CITY OF REDONDO BEACH
PUBLIC WORKS DEPARTMENT
ENGINEERING SERVICES DIVISION

ADDENDUM NO. 2

Date: October 18, 2016
To: All Bidders
From: City Engineer
Subject: **Addendum No. 2- Ensenada Parkette Improvements Project, Job No. 30620**

SECTION H
DRAINAGE SYSTEM
NO SCALE

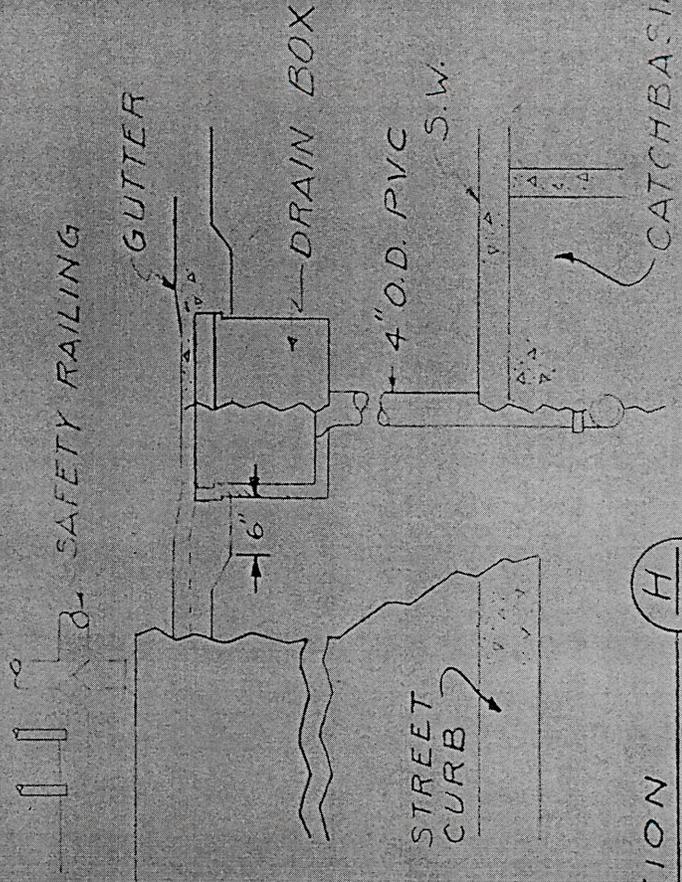
4. There are two existing area drains as shown on plans: the one on Goodman Avenue side is to be replaced in kind including the drainage piping system to existing street catch basin and the 3" perforated PVC drain pipe of the new retaining wall is connected to this area drain system; and the one on Armour Lane side is to be replaced in kind, relocated in the planter, and connected to existing drainage piping system at its old location (shown in new concrete slab area). The play area drainage system shall connect to the relocated, replaced in kind area drain on Armour Lane side. A copy of existing area drain system detail is attached for reference.
